## COUNCIL REPORT

Report Date: June 23, 2026

SUBJECT: CD-1 Amendment: CD-1 (499) East Fraser Lands Area 2 South: 3202-3270 Riverwalk Avenue (Parcel 11)

**Figure 2: Proposed Relocation of Parking Structure (Parcel 11)**

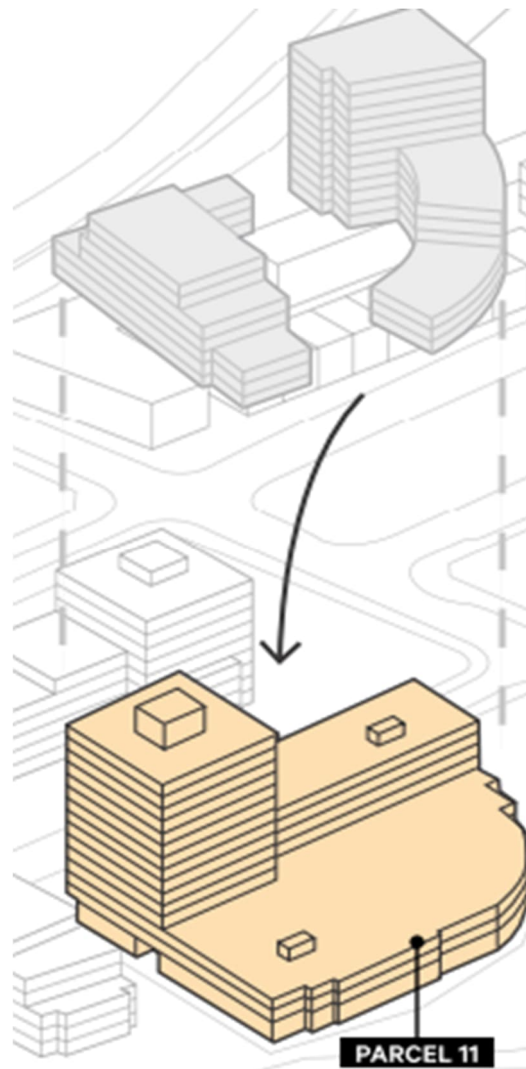
Relocating a portion of the required parking from underground levels to the lower parts of the proposed building changes the ability to include pedestrian connections through within interior courtyards due to above-grade parking. Figure 2 demonstrates the change in form as a result of the proposal. This approach keeps the overall amount of parking the same, but avoids the need for deep excavation. Area planning goals will be maintained by ensuring that parking is hidden from the street and public plazas by wrapping it with commercial or residential uses on primary streets and maintaining walkable, active frontages, while making construction more practical and financially feasible.

**Figure 4: Proposed Massing**

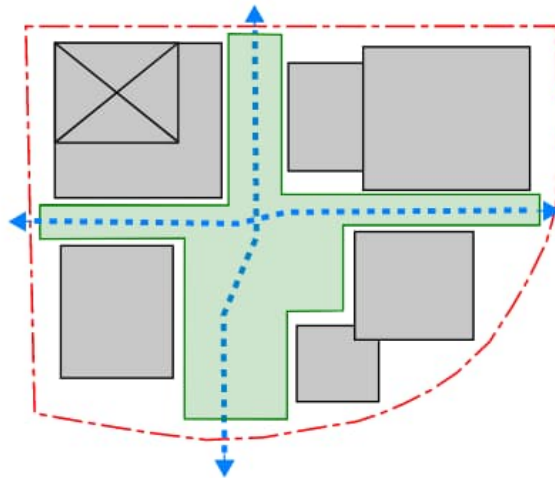
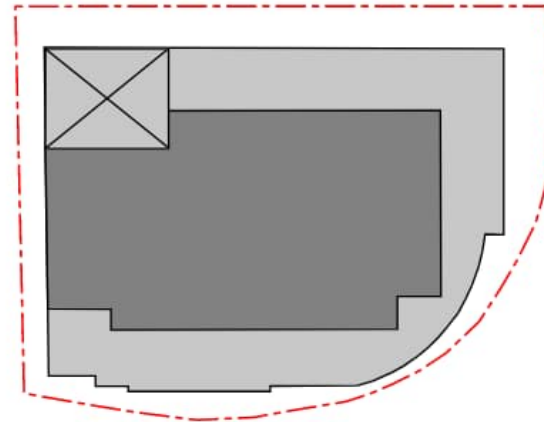
connections and soft foreshore edge envisioned in the <i>ODP</i> . The lack of semi-private landscaped space further reduces open space diversity and the project's contribution to the foreshore character.	the courtyard with above-grade parking which is wrapped with active uses.
<b>Building Massing-Tower Floorplate</b>	<b>605 m<sup>2</sup></b> (6,500 sq. ft.)	<b>743 m<sup>2</sup></b> (8,000 sq. ft.)	The proposed tower floorplate is larger than anticipated in the <i>ODP</i> , which may result in incremental increases in shadowing and modest impacts on access to daylight and views within the surrounding public realm.	Staff have assessed the impacts as relatively minor and given its location away from the park, recommend support.
<b>Setbacks</b>	<b>5.5 m (18 ft.)</b> (southern and eastern yards)	Approx. <b>3 m</b> (southern and eastern yards)	The insufficient setback between the building and the property line results in a weak spatial transition and limited visual and physical connection to the public realm, particularly along the foreshore frontage.	Refer to Condition 1.1 for strategies to improve the transition.

<b>On-Site Open Space</b>	Provision of open space in form of a courtyard. (Figure 3)	No on-site open space is provided. (Figure 4)	The proposal does not achieve the broader public open space objectives outlined in the <i>ODP</i> , as it lacks permeability within the building massing in the form of semi-public and semi-private open spaces intended to complement the public realm, strengthen access to Riverfront Park, and enhance the overall waterfront experience.	Due to the relocation of parking from below grade to above grade, the provision of a courtyard at grade is no longer feasible. Condition of Approval 1.2 seeks to provide a commensurate area to that lost through the transition to above-grade parking.
<b>Public Realm Interface</b>	High-quality interface	Not aligned with <i>ODP</i> and Design Guidelines expectations	The continuous, unarticulated podium massing diminishes the public realm interface and doesn't transition to the foreshore as anticipated by the current masterplan. The setback is also insufficient to accommodate private patios at ground level.	Refer to Condition 1.1 for strategies to improve the public realm interface including locating more active uses on the building face, landscape screening, and increased setbacks.

<b>Parking</b>	Underground parking (Figure 3)	Above ground parking (Figure 4)	The proposed above-grade parking is screened by residential uses along the park and shoreline, as well as at grade along Riverwalk Avenue, minimizing its visibility. Partial exposed parking is proposed to the west.	Refer to Condition 1.1 for strategies to improve the public realm interface.
----------------	--------------------------------	---------------------------------	--	--

- (b) The façade facing Kinross Park should be fully wrapped with active uses at all levels.
- (c) Considering high-quality screening of any exposed above-grade parking, or the use of other strategies such as increased setbacks to minimize impacts on the public realm.

1.3 Design development to explore additional opportunities for on-site public open space;

Note to Applicant; The intent is to provide approximately commensurate area to that lost through the transition to above grade parking.
